From: Andrew Page Page Partnership
Sent: 15 January 2016 11:54
To: Hannah Barker
Cc: Steven George
Subject: Re: 5 The Lynchetts Shoreham By Sea AWDM/1259/15
Attachments: Drg10D.G.Flr and SitePROP.pdf; Drg11D.Elvs and SctsPROP.pdf; Drg15.SewerLocation.pdf

Client
Mr & Mrs George
5 The Lynchetts
Shoreham-by-Sea
BN43 5GZ

Job Title
PROPOSED REAR AND
SIDE EXTENSION

Drawing Title
BUILDING AS
PROPOSED
Ground Floor Plan

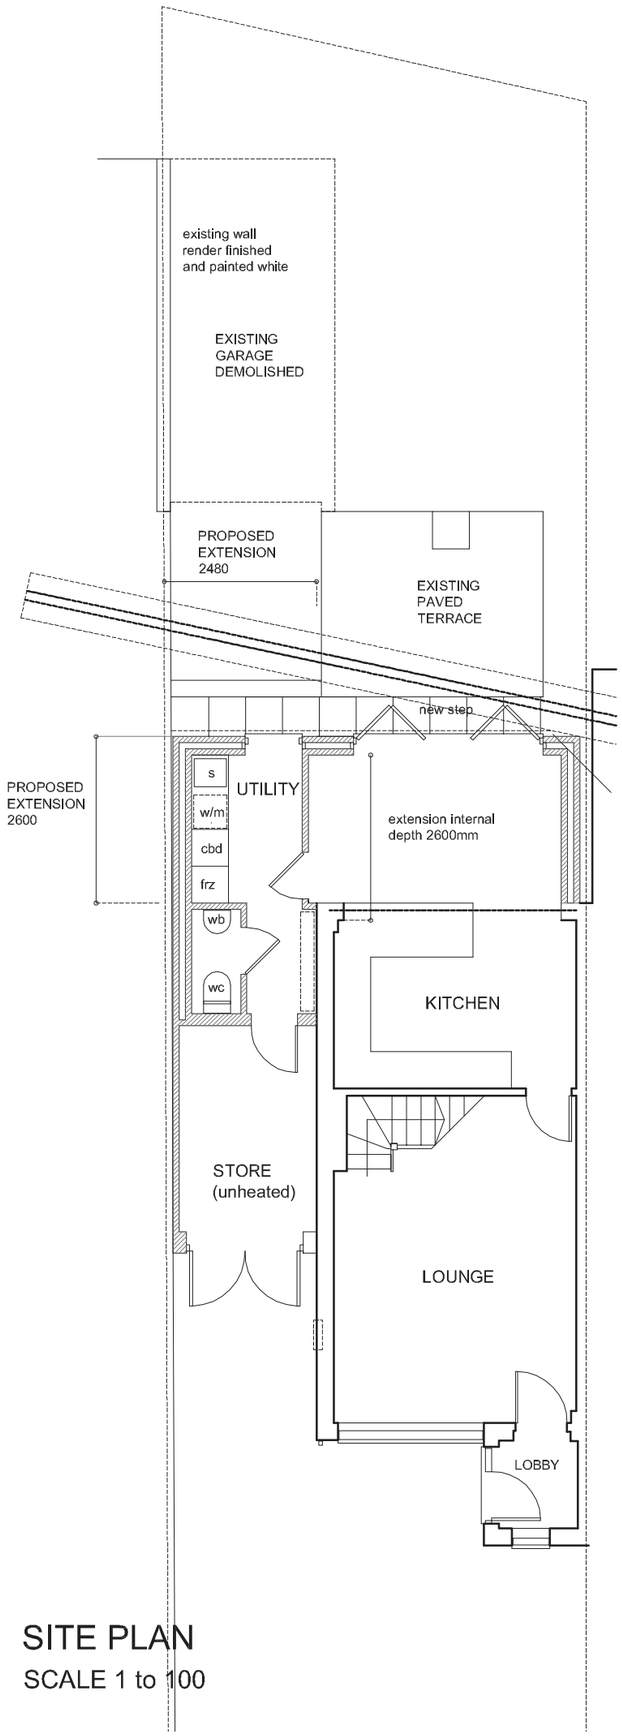
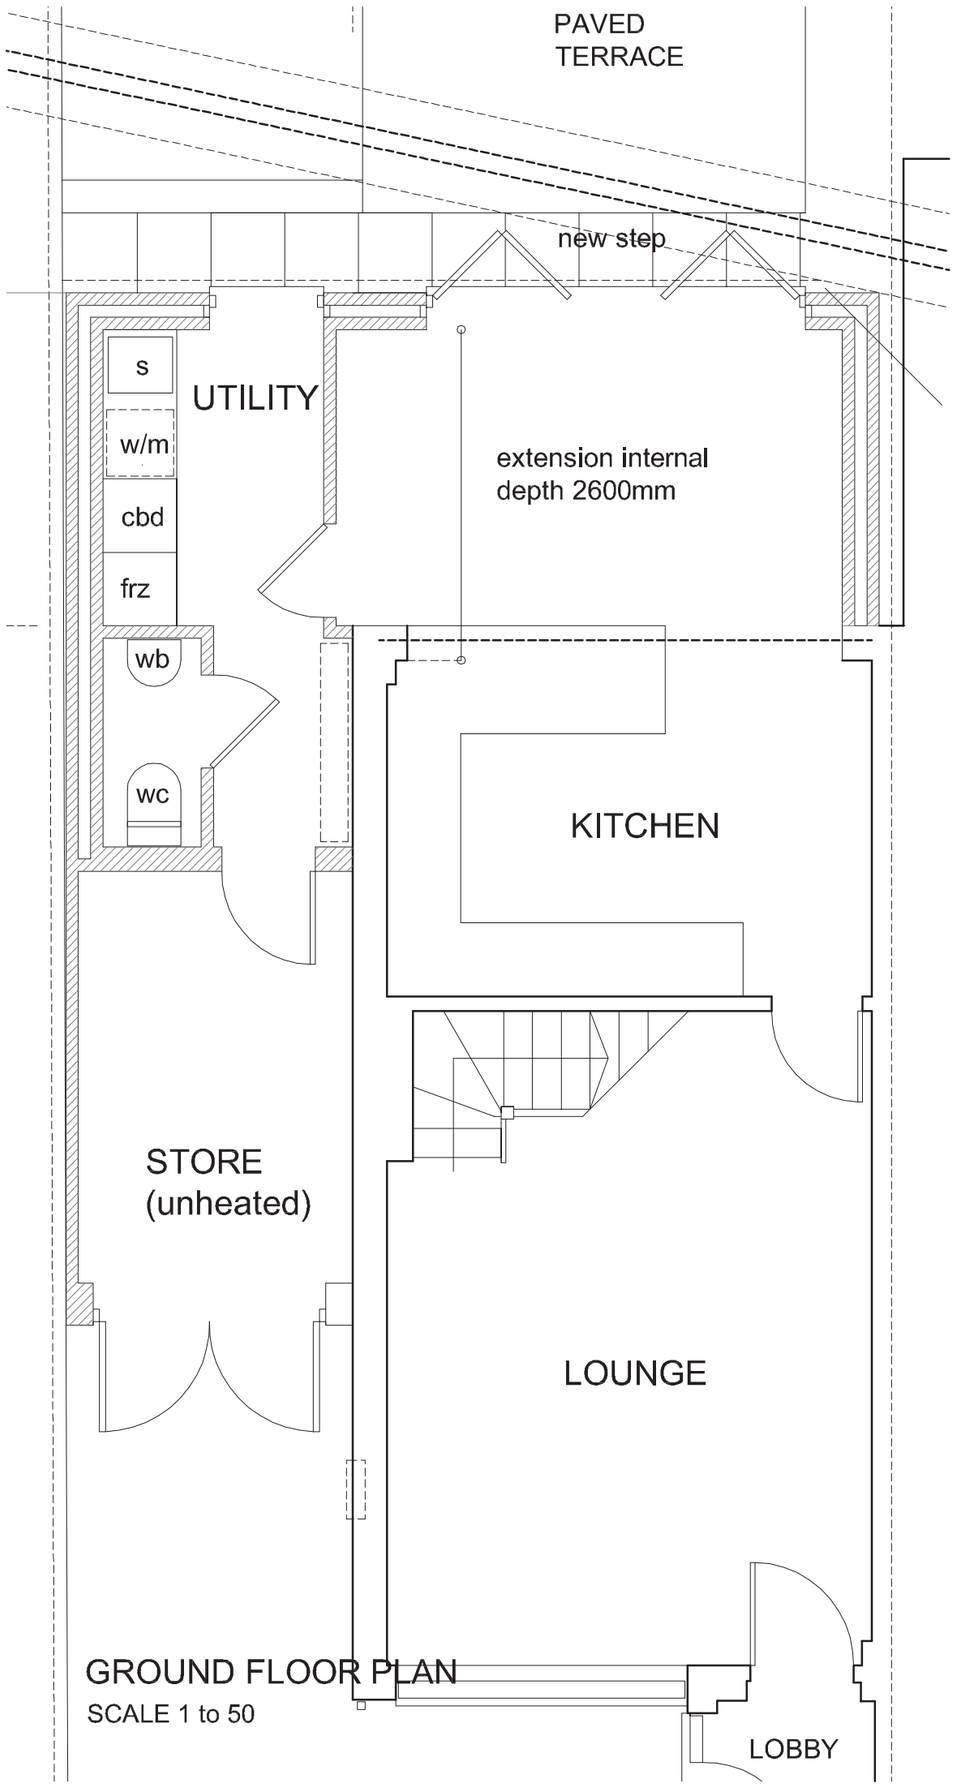
REV D: 15.01.16 Final adjustments to extension depth.

REV C: 07.01.16 Side extension reduced to original line, rear extension reduced to meet sewer exclusion zone requirements

Please find attached amended drawings 15530/10D & 11D indicating the rear extension reduced by 300mm to meet this requirement. Also attached is drawing 15530/15 showing the pipe and exclusion zone in detail.

Drawing Title
BUILDING AS PROPOSED
Scheme Drawing
Elevations and Sections

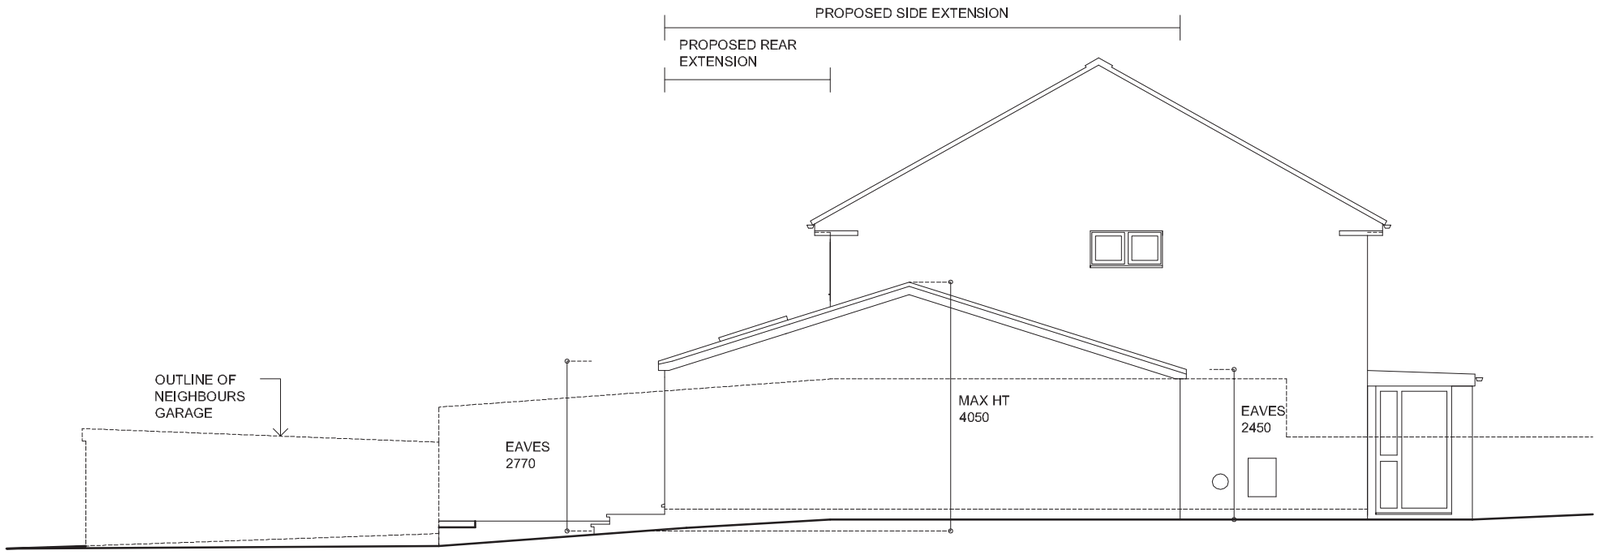
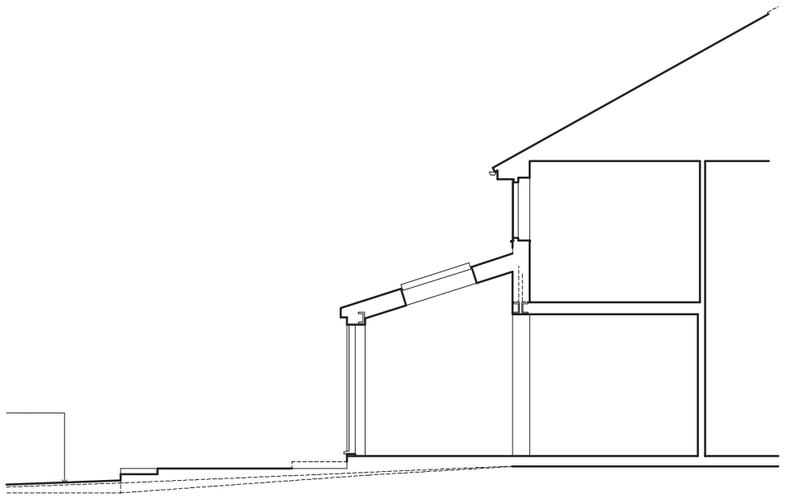
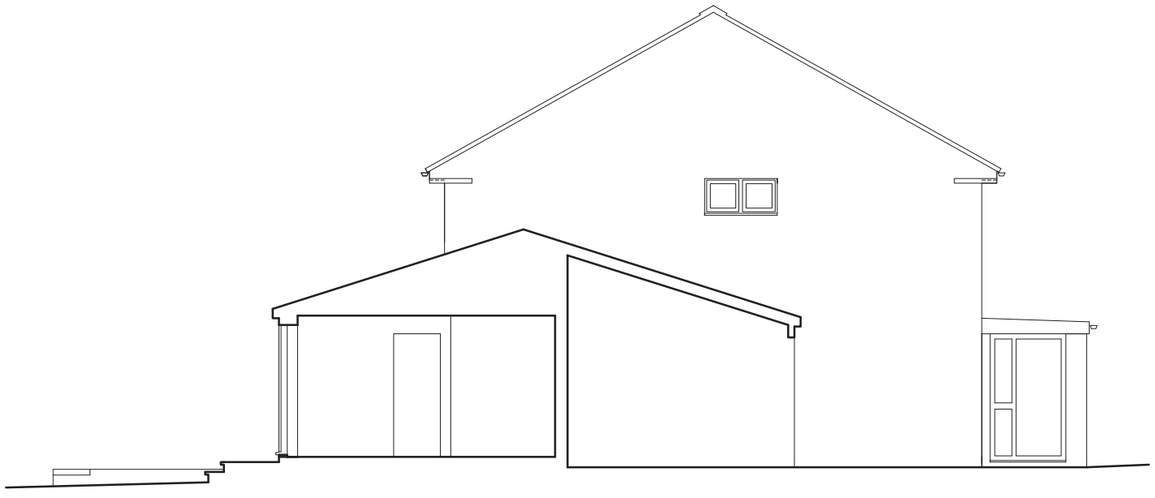
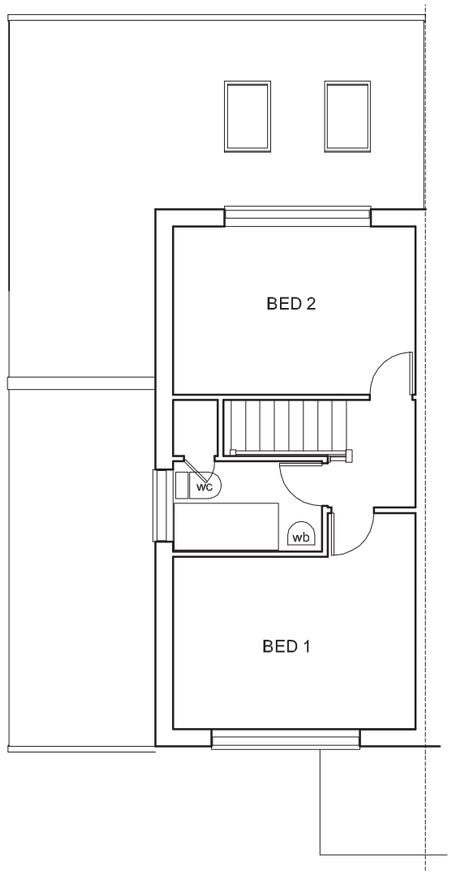
REV D: 15.01.16 Rear extension depth adjusted to sewer location. Side extension returned to original depth.

Drawing Title
BUILDING AS
PROPOSED
Ground Floor Plan
Revised rear extension
to meet sewer exclusion
zone requirements

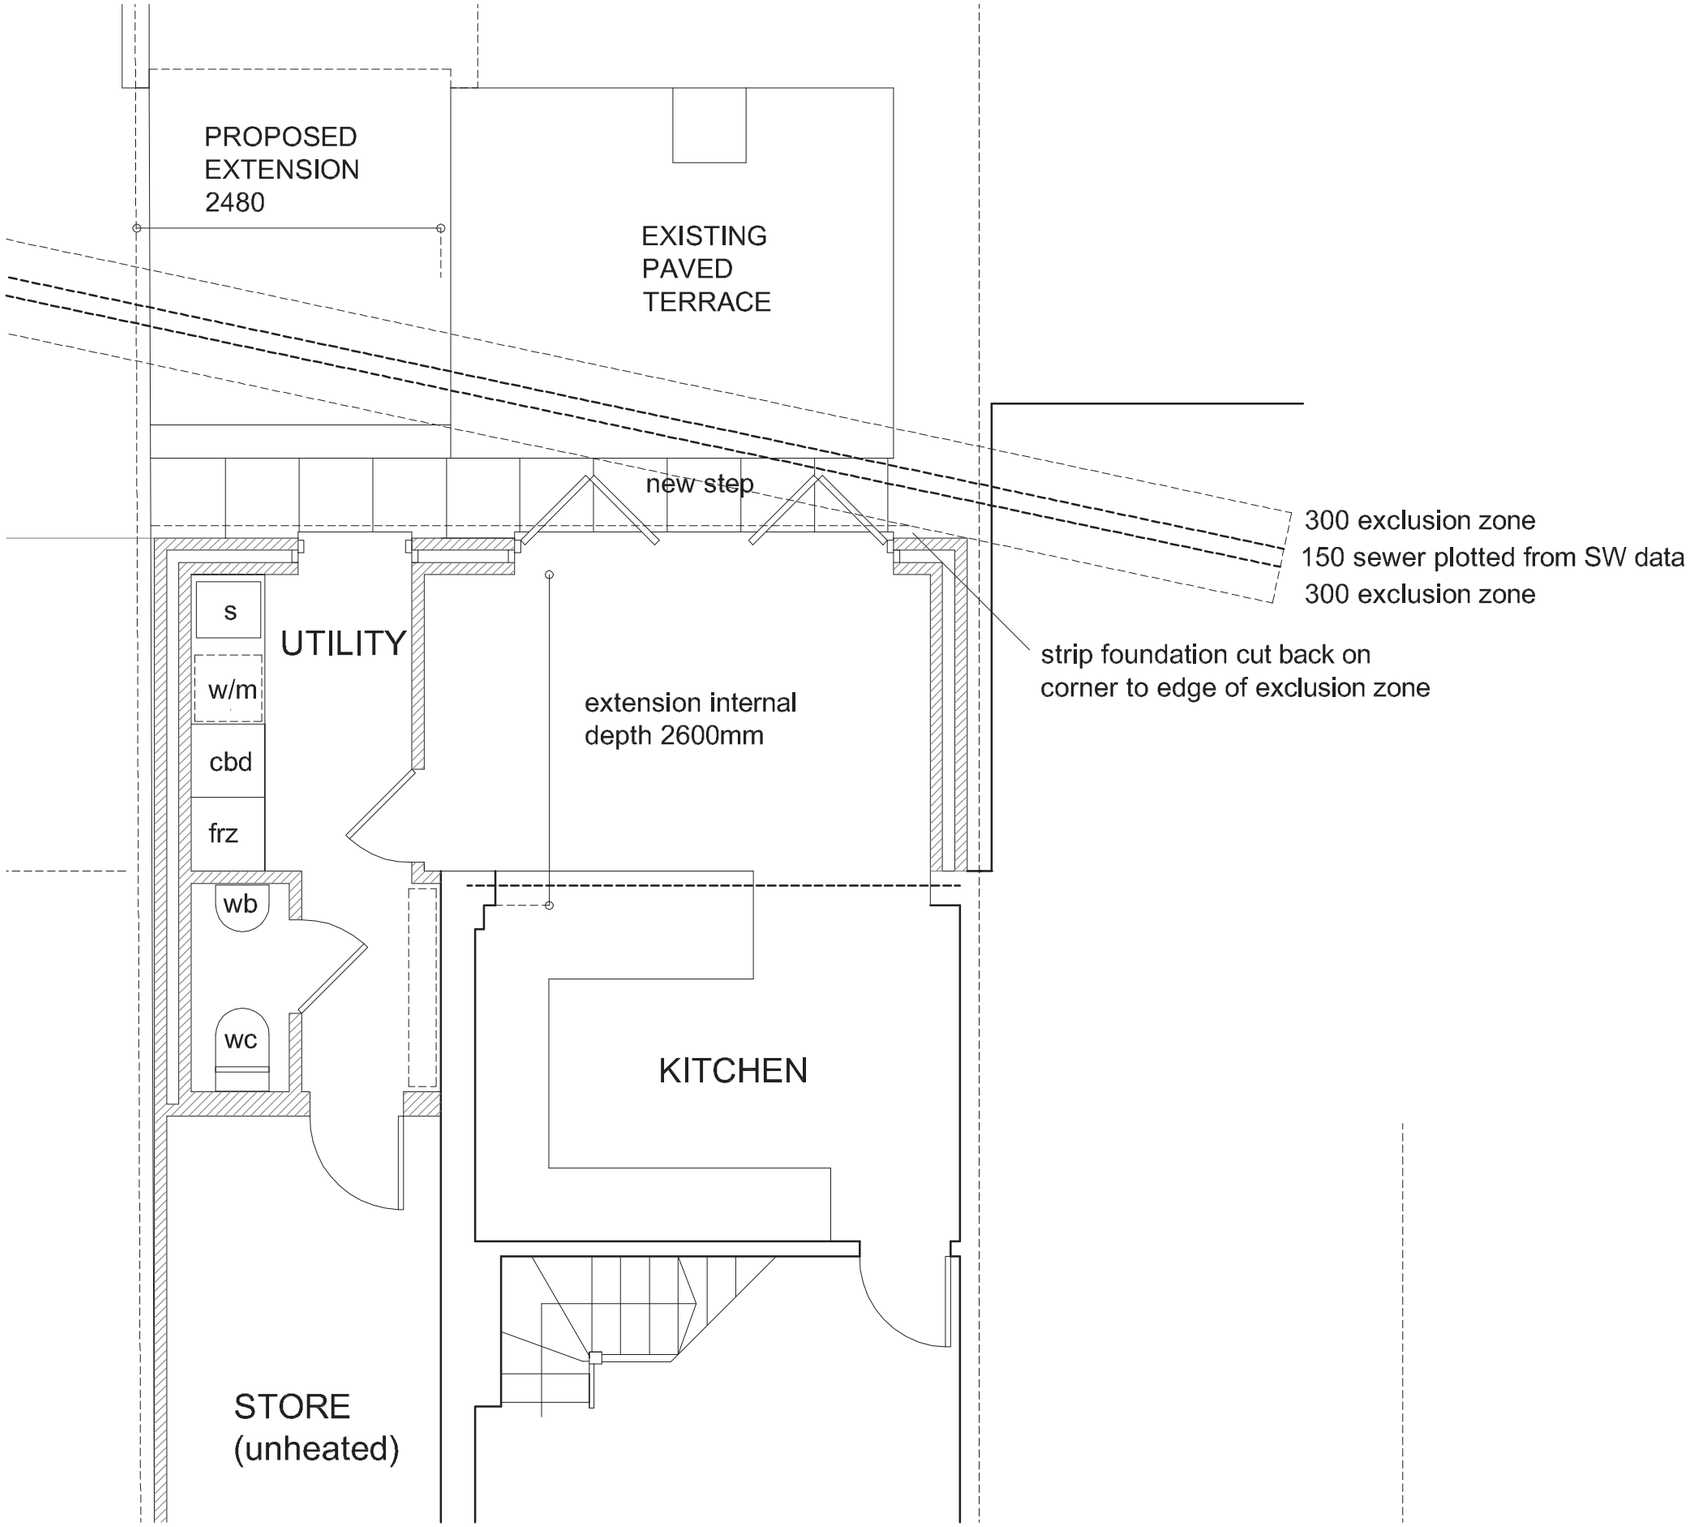
Southern Water have asked for the extension rear wall to be relocated away from the sewer. The standard width of the exclusion zone they require from the pipe is 500mm but they have agreed (verbally) to reduce this to 300mm.
